RAI Volume 3, Chapter 2.2.1.3.2, Second Set, Number 5:

1.1 STRUCTURAL RESPONSE OF A WASTE PACKAGE UNDER A COLLAPSED DRIP SHIELD

Figure 1. Geometrical Representation of the Waste Package Loaded by the Collapsed Drip Shield for the Case of Degraded Internals

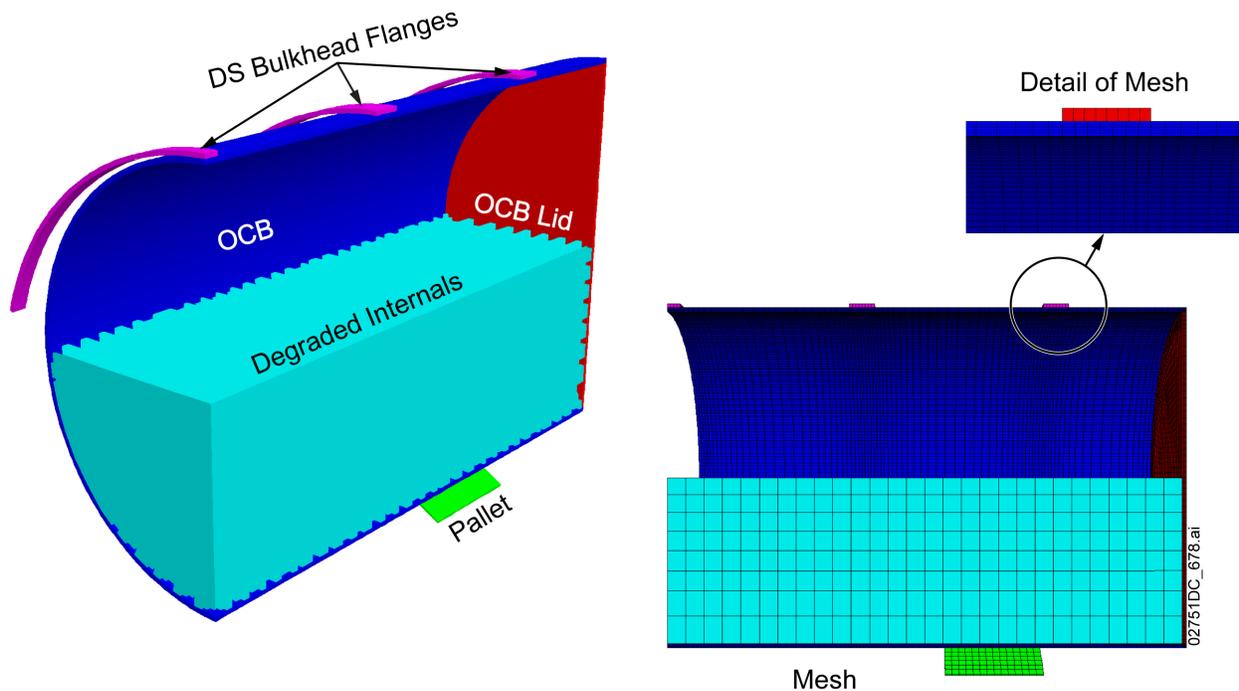
Explain how the potential for tensile tearing of the waste package under a collapsed drip shield is bounded by the strain analyses for intact or fully degraded drip shields, such that the potential for tensile tearing is not underestimated.

The geometry for the DOE analysis of a waste package loaded by a collapsed drip shield is illustrated in Figure 1 (SNL 2007a, Figure 6-90). The model representation encompasses a quarter symmetry of the total waste package. Thus, it includes half of the two end bulkhead flanges and a quarter of the middle bulkhead flange of the drip shield. Figure 1 shows the waste package with fully degraded internals; a quarter-symmetry representation is also used for the waste package with intact internals (SNL 2007a, Figure 6-89).

In the structural analysis for this configuration, the drip shield bulkhead flanges are pushed uniformly downward against the outer corrosion barrier (OCB). This downward motion occurs slowly enough that the OCB is always near equilibrium, and is referred to as a quasi-static loading or quasi-static (as opposed to dynamic) analysis. The total load on the OCB increases as the bulkhead flanges are pushed downward, resulting in increasing the damaged area on the OCB, as shown in SAR Figure 2.3.4-93.
